Administrative Board of Review Meeting
Wednesday, October 1, 2025 - 4:00 PM
AGENDA

SITE PLAN COMMENT LETTER

Request: Approval of a final development plan by the ABR based on the submitted site and architectural plans for Cologix Building 1.

1 WEST ELEVATION
1/8" = 1'-0"

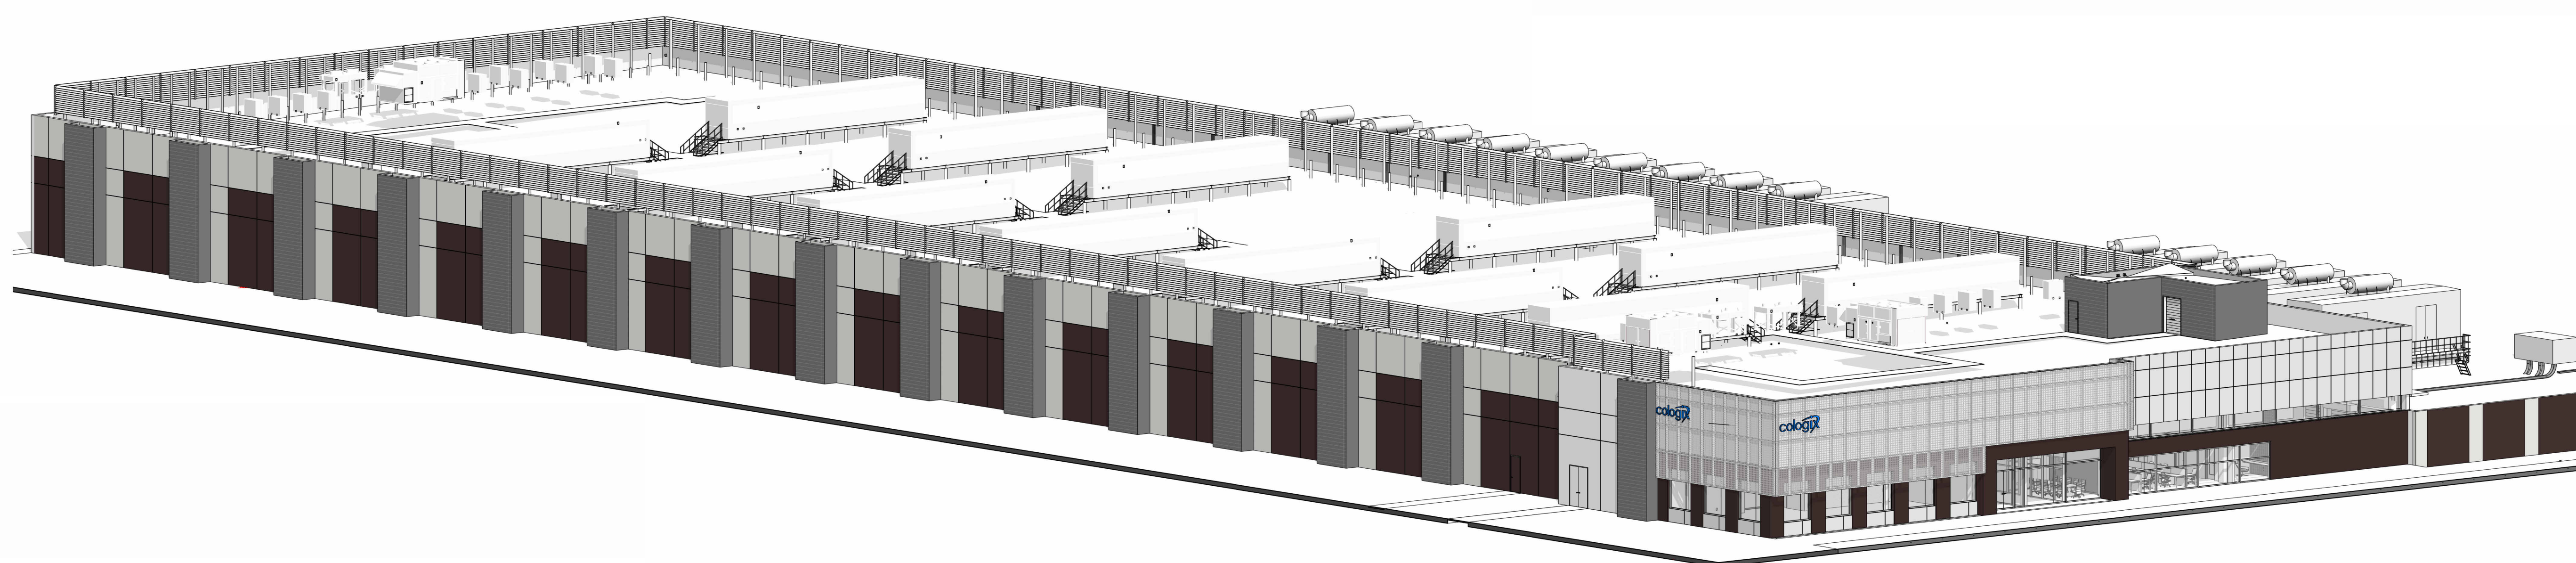
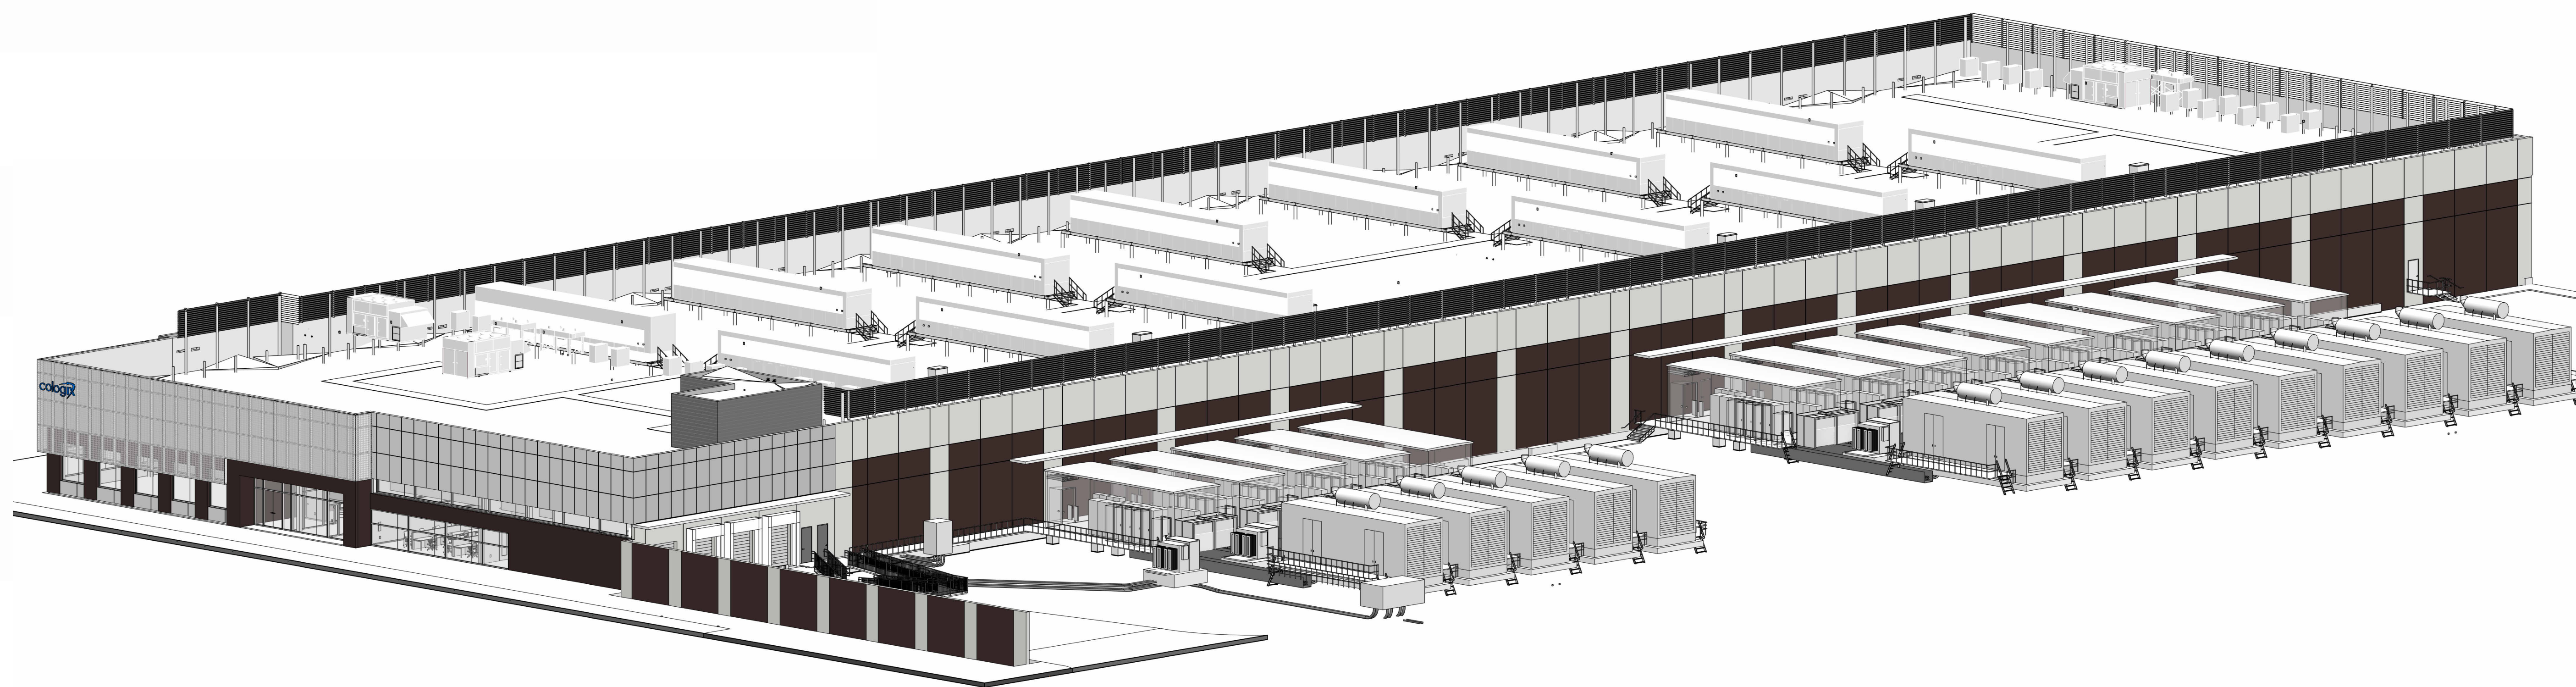
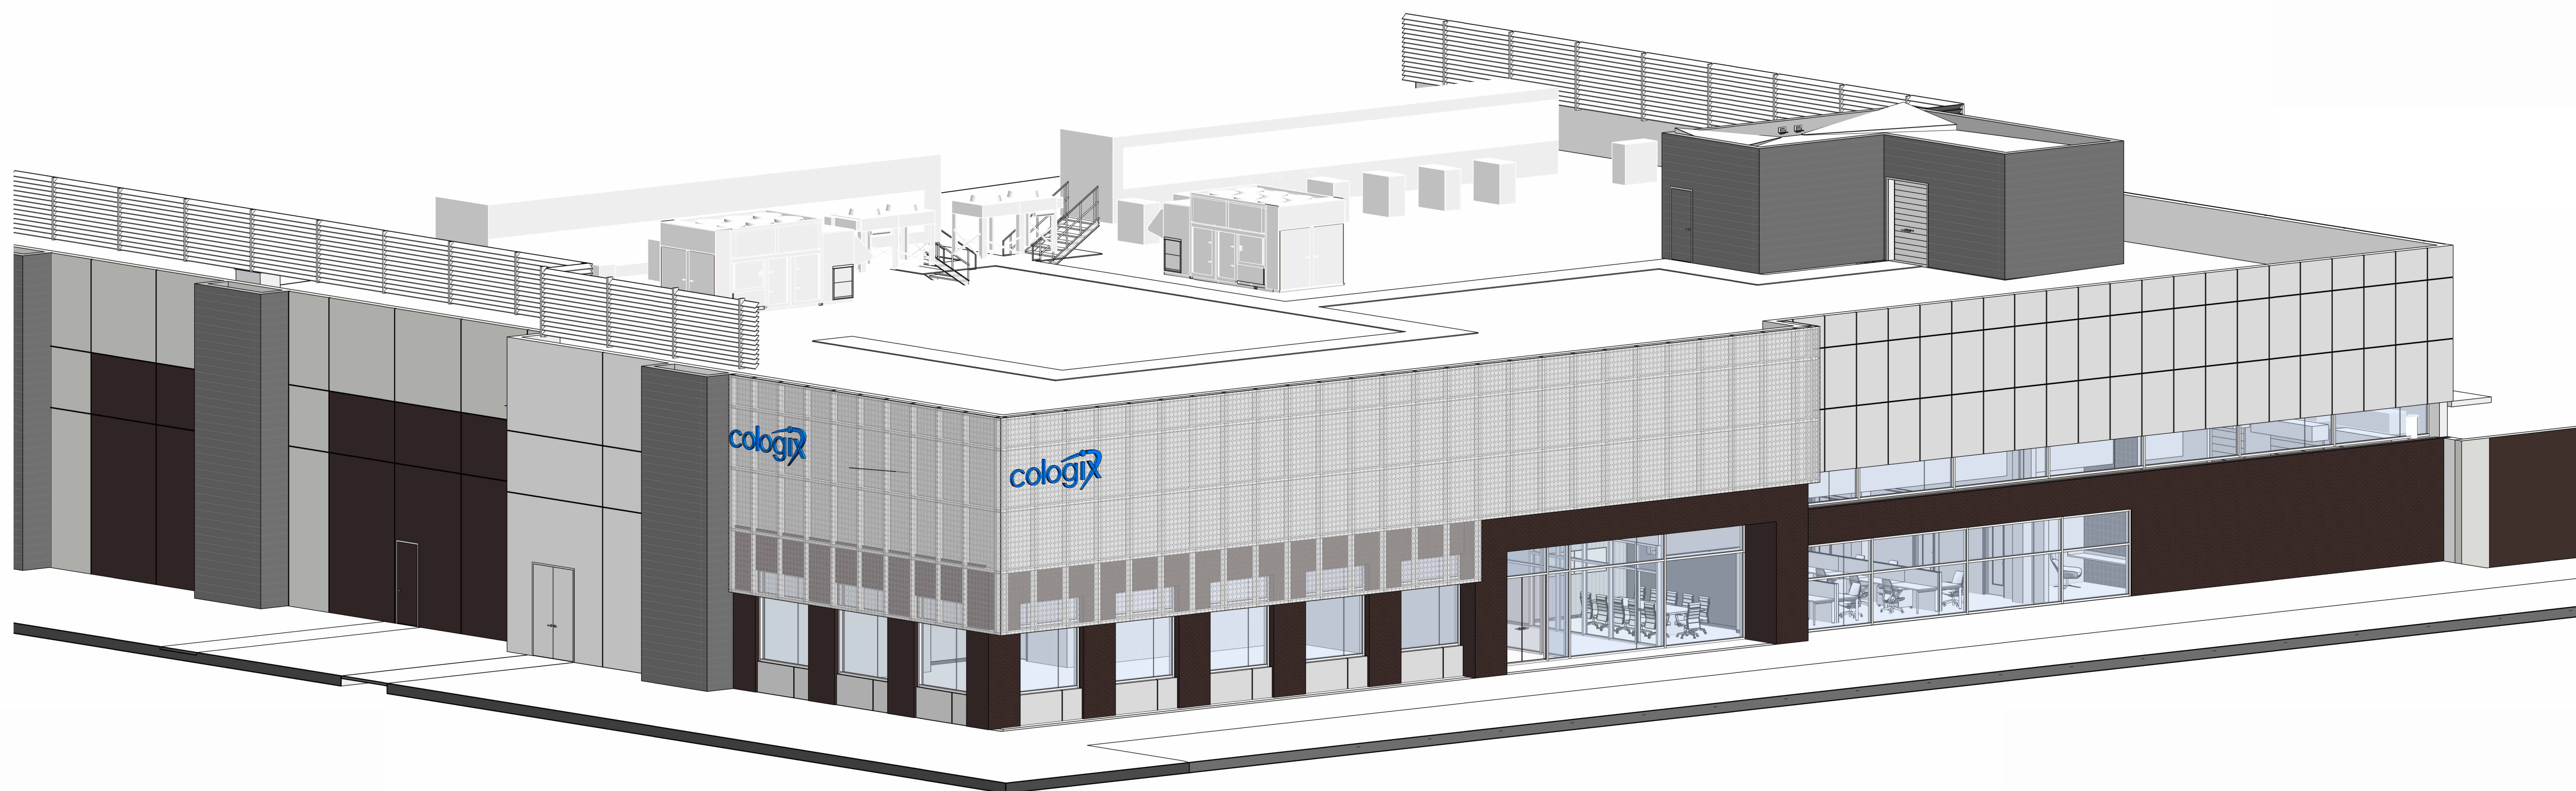
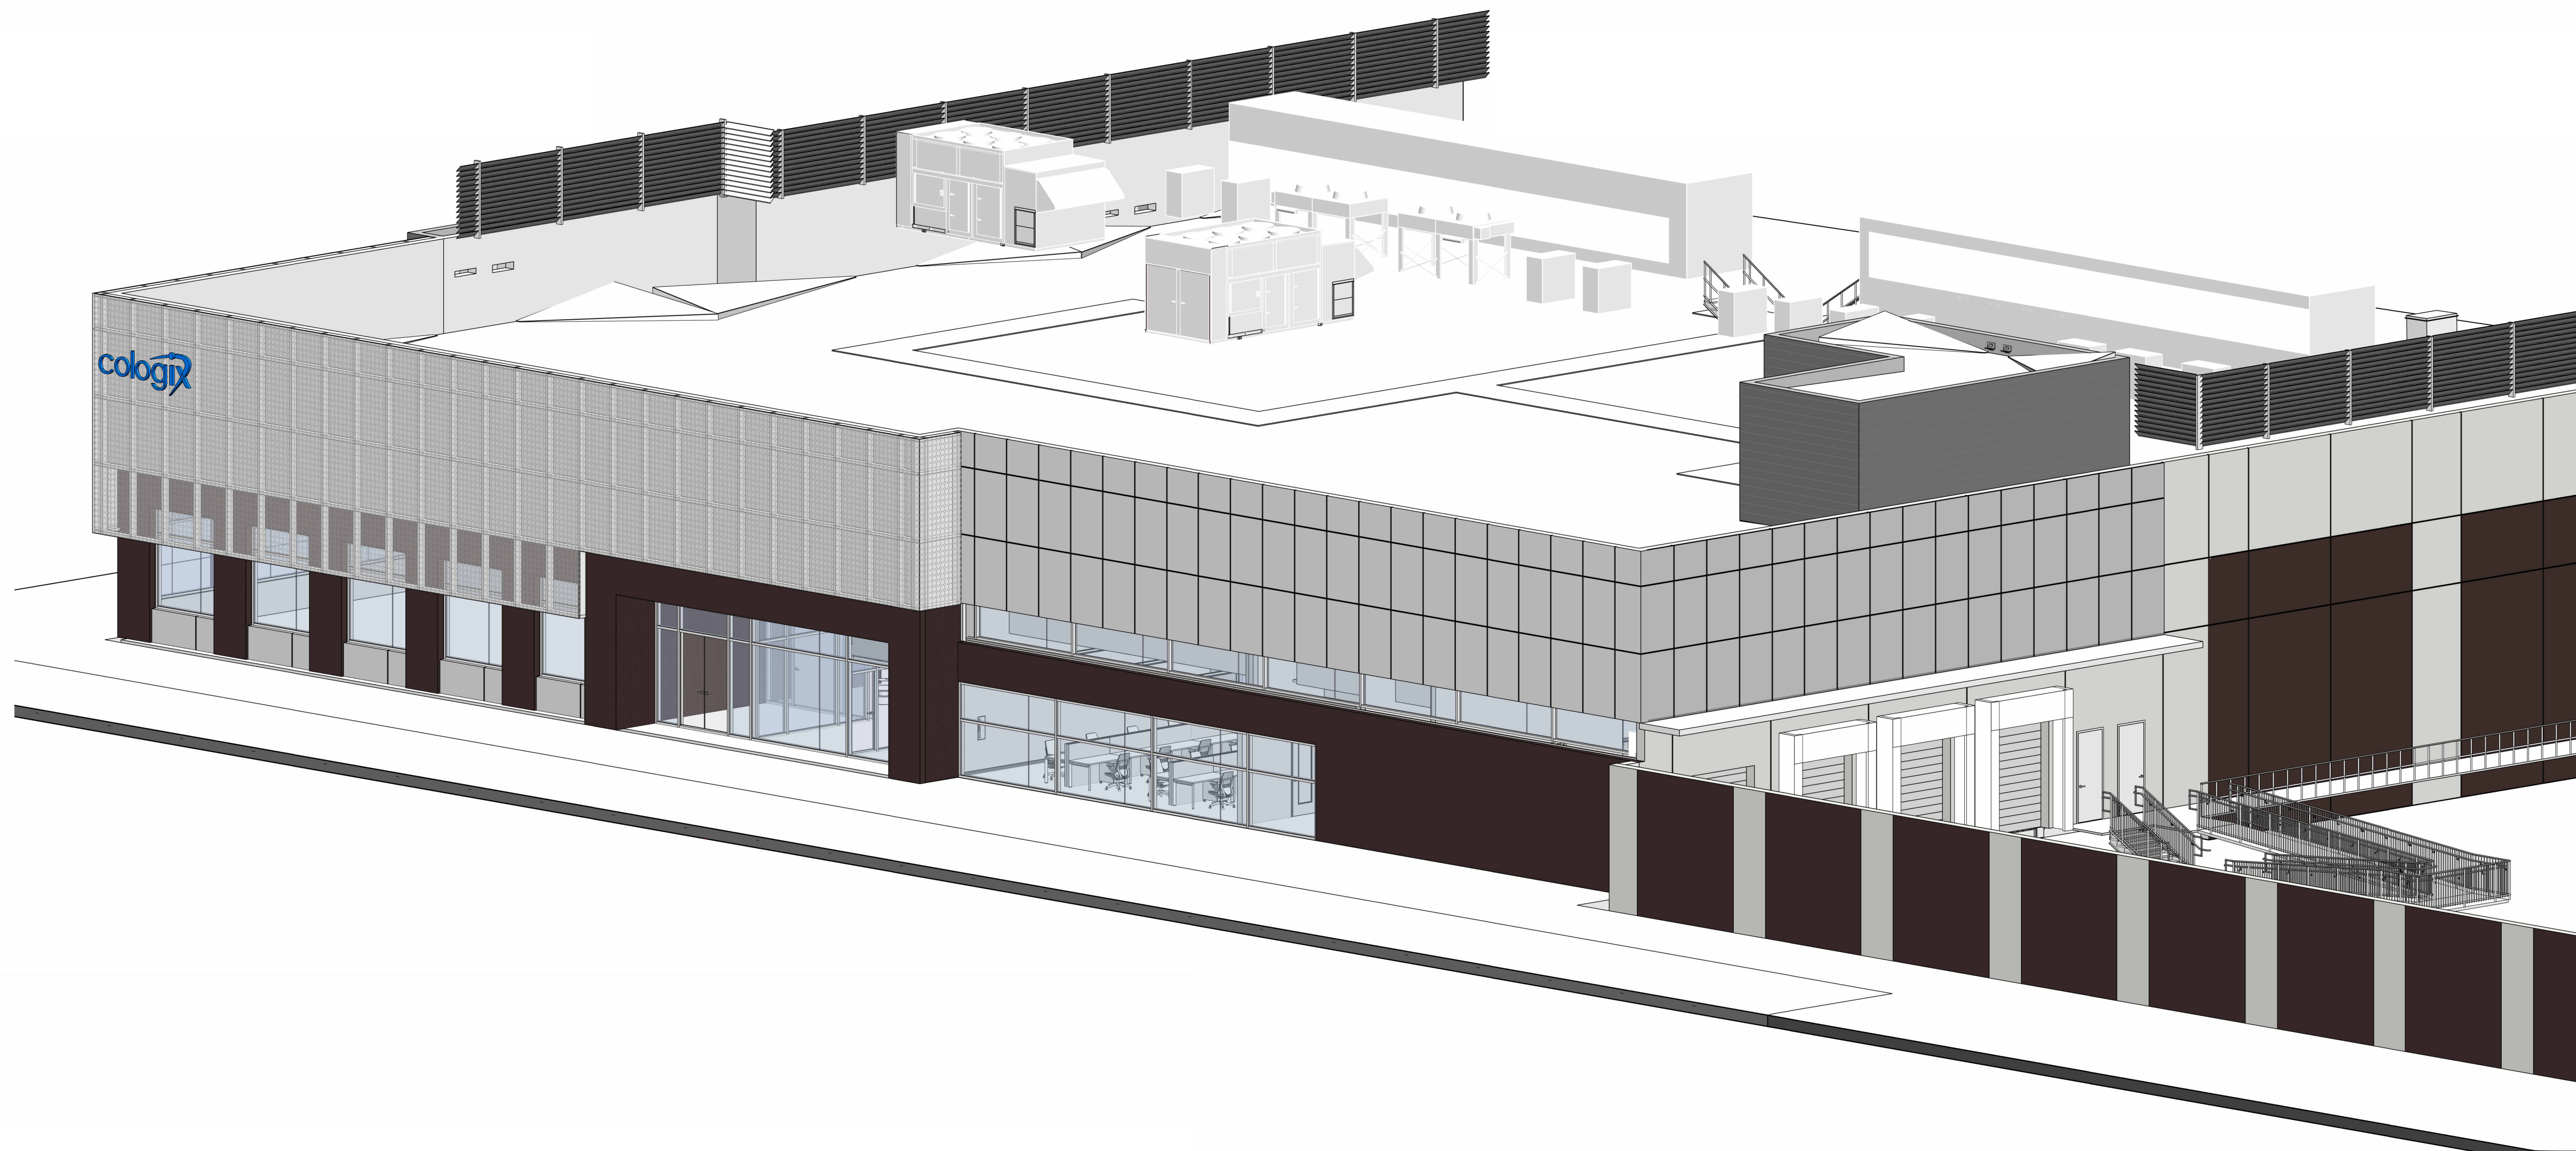
Reviewer Comment: Illustration 5.4.2 of the zoning text establishes photo references for Data Center architectural styles. While architectural review is subjective, the proposed building elevations use a mix of materials arranged in a way to break up long stretches of walls, and blend modern and traditional materials similar to the photos in the zoning text.
